INTERNATIONAL ORGANIZATION OF MOTOR VEHICLE MANUFACTURERS

Stable Acceleration in ASEP

Review GRB Data 2007 and Recent OICA Data

ASEP Database 2007 + Extension 2016 – GEAR 2

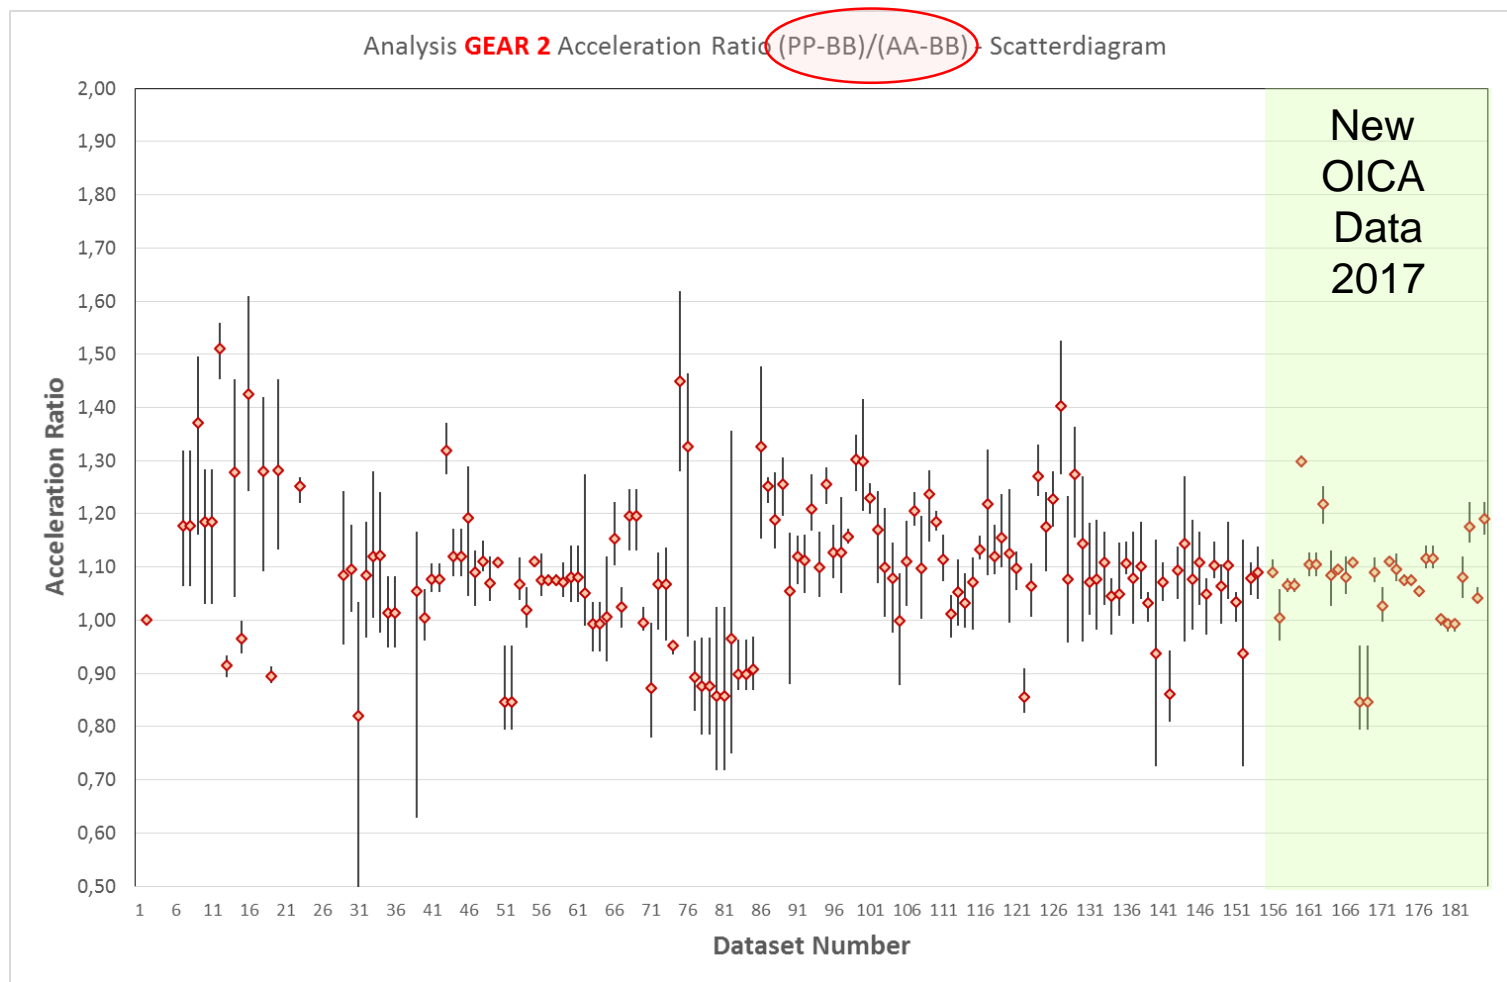
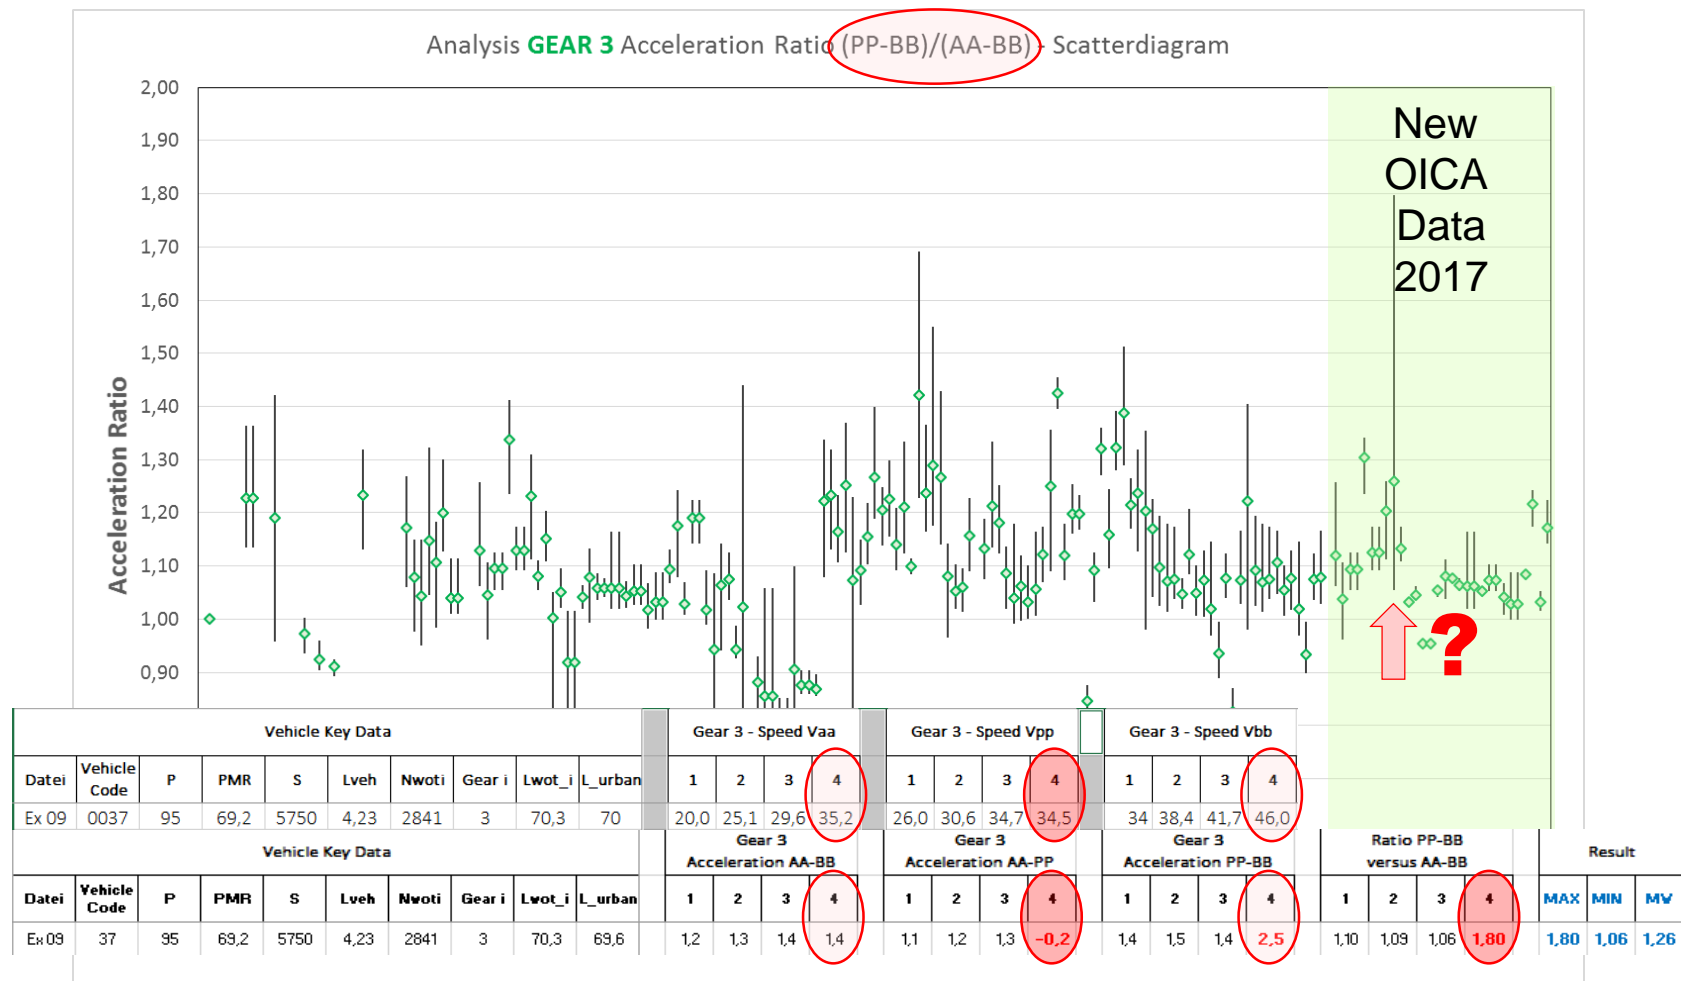
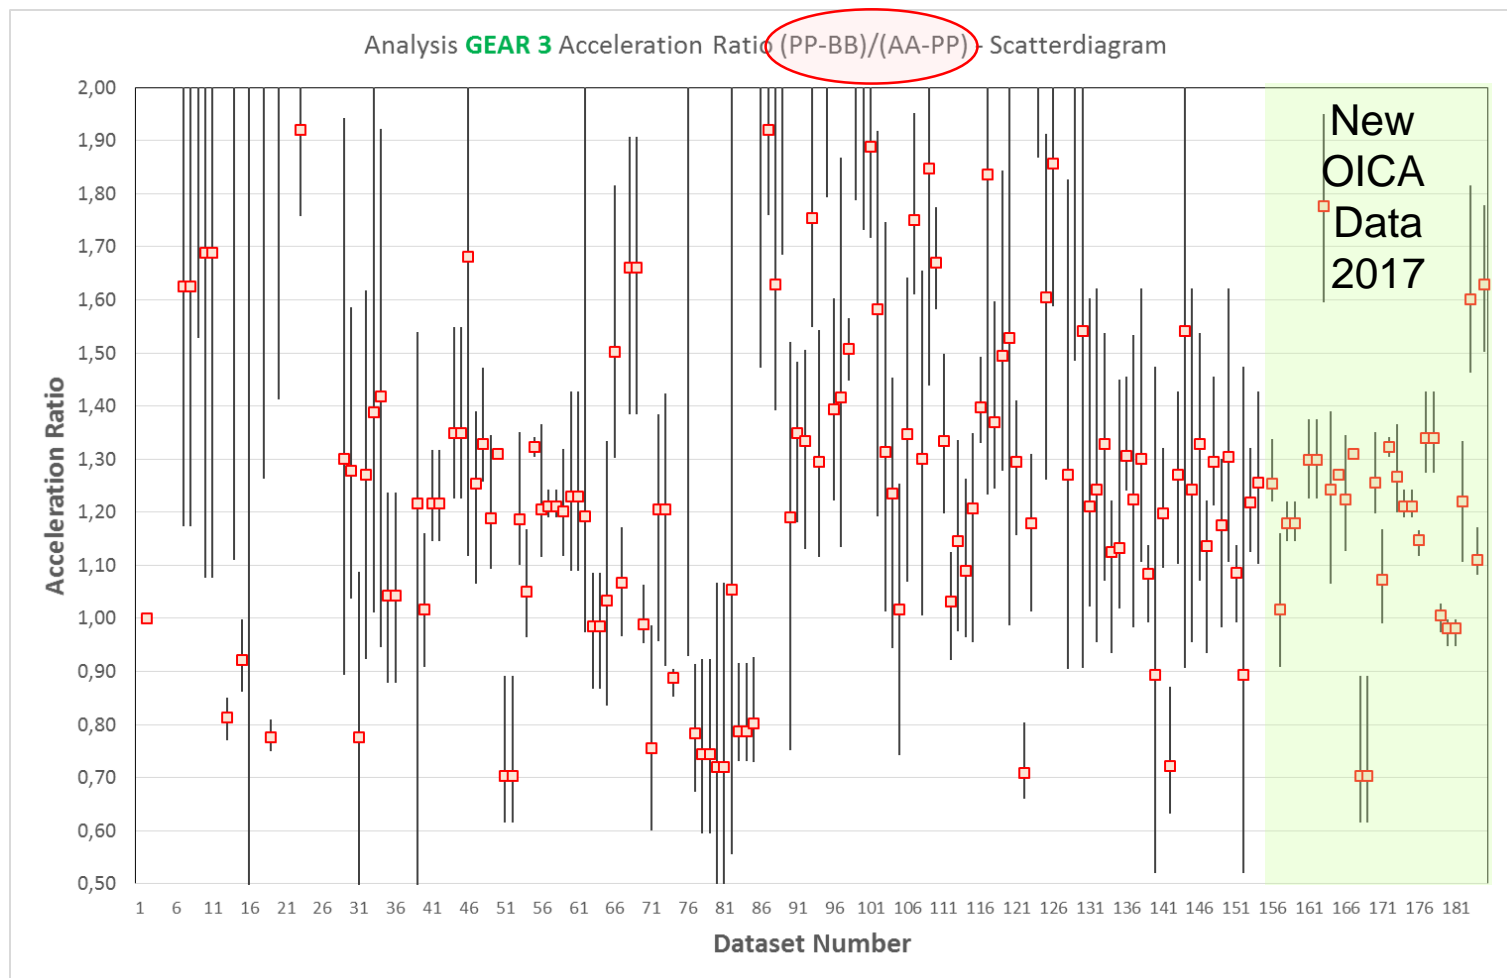
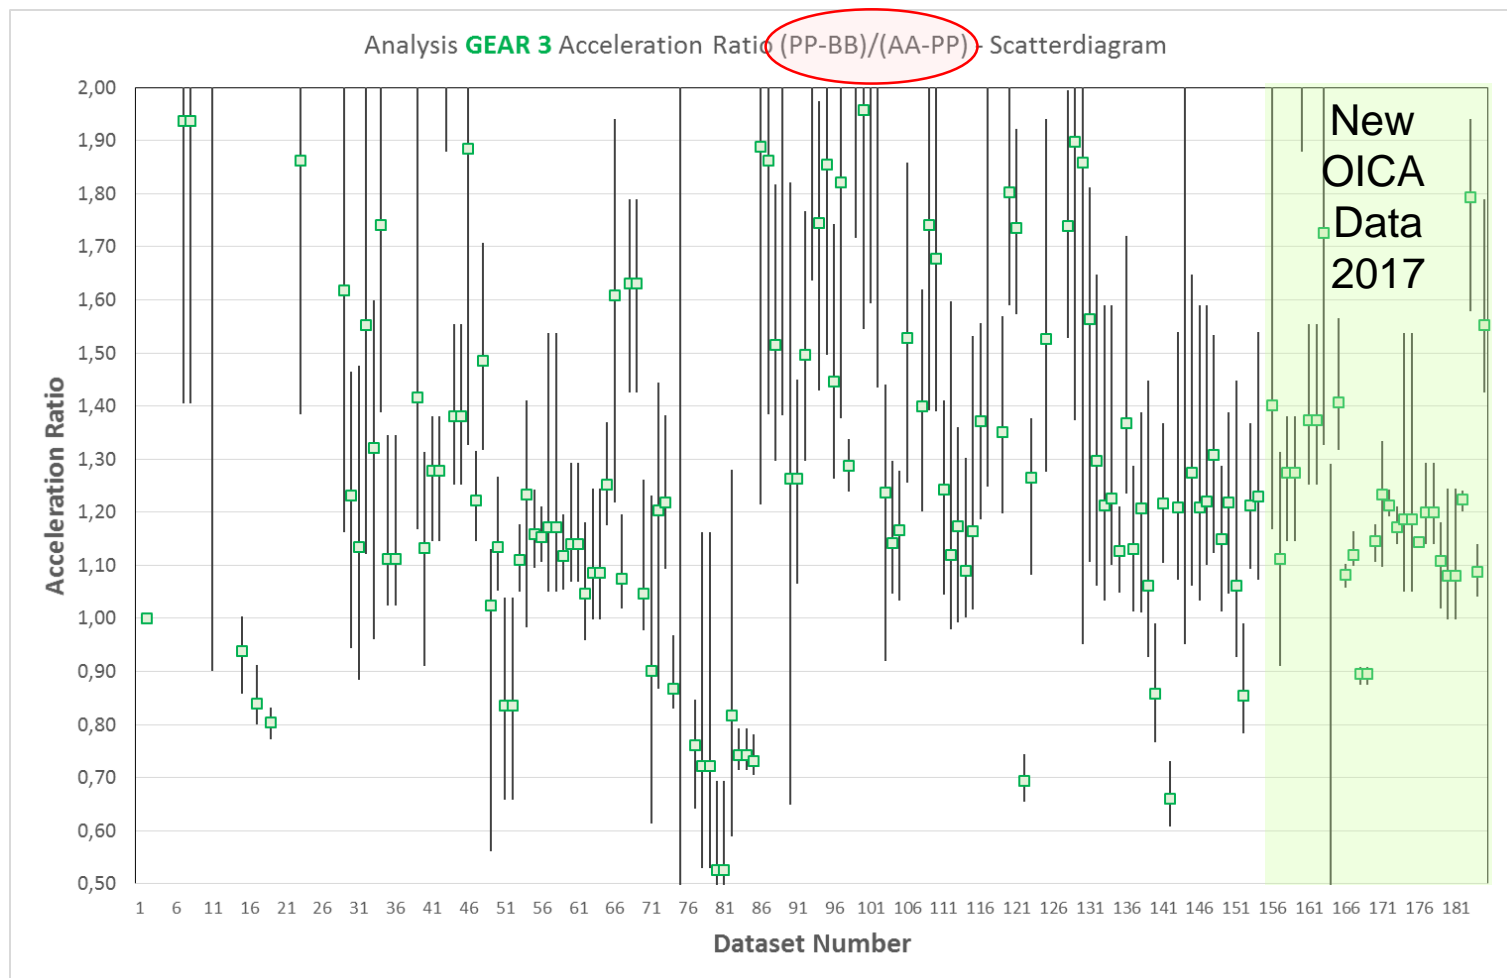
- The acceleration ratios between $a_{(PP-BB)}/(AA-PP)$ show too big scatter and are not suitable for a stable acceleration definition. A potential mal-measurement is exponentially rated.
- The acceleration ratio between $a_{(PP-BB)} / a_{(AA-BB)}$ is much more stable.
- Impact on Slope-Assessment:
 - For the slope assessment, the variation in acceleration does not play a role.
- Impact on L_{urban} -Assessment:
 - The calculated/reported acceleration is part of Pseudo- L_{urban} calculation.

2.26.1. "Stable acceleration" is given when the acceleration ratio $a_{(PP'-BB')}/a_{(AA'-BB')}$ is lower than 1,2."

Uncertainty Assessment - Variation of the Acceleration

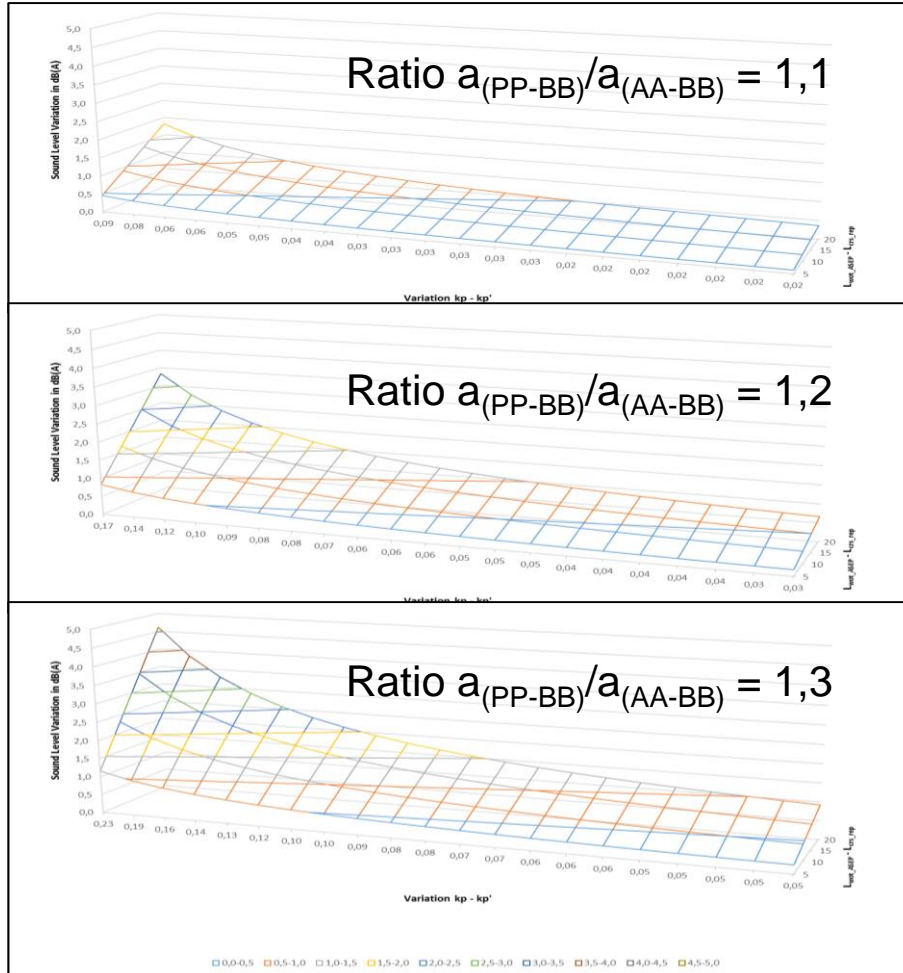
- The influence on the test result is higher, if the acceleration is closer to a_{urban} . The impact is 1,0 dB to 4,5 dB on the test result.
 - This is the typical area for gear 2 of vehicles with lower PMR and higher gears for all vehicles
- Extreme high accelerations ($a_{wot_ASEP} > 3 \text{ m/s}^2$) are less affected by the variation of the acceleration. The impact is 0,5 dB to 1,5 dB on the test result
 - This is the typical area for gear 2 and sometime gear 3 of vehicles with high PMR.
- For a better precision, the ratio should be lower.

Review Database 2007+ Ext. 2016 – Statistics

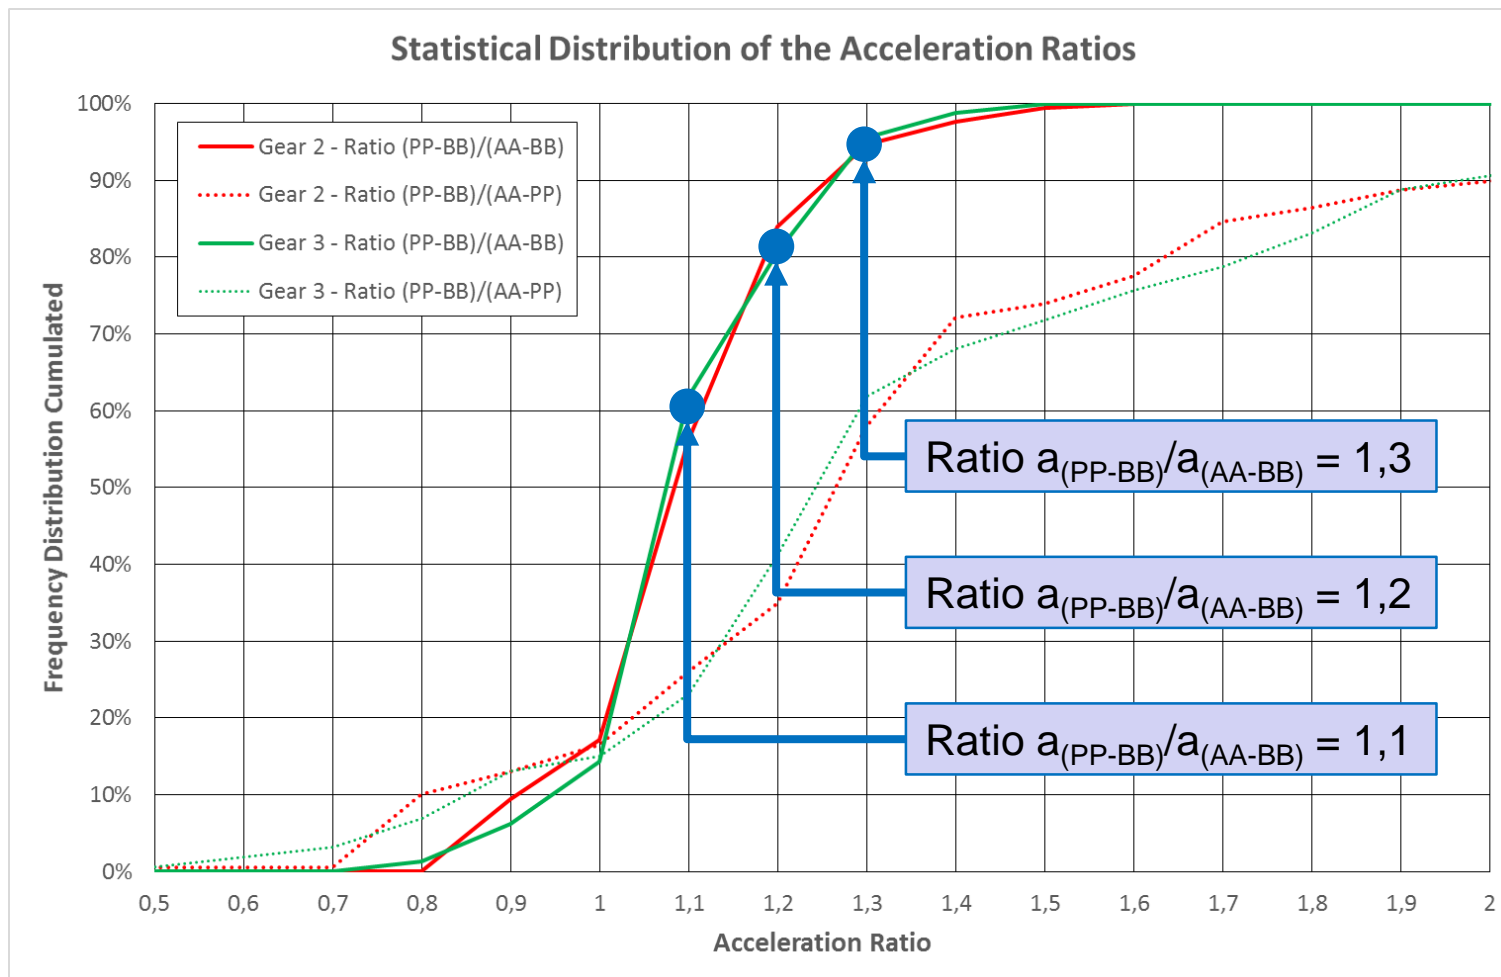
- This proposal makes the trade-off between accuracy and frequency of application.
- ***Alternatively, it could be considered, to calculate in general the acceleration from the second half of the test track for all ASEP measurements.***
- It is more accurate to determine the instantaneous acceleration at the point where the maximum sound level occurs.
- However, latter suggestion will need more consideration on mandatory test equipment.
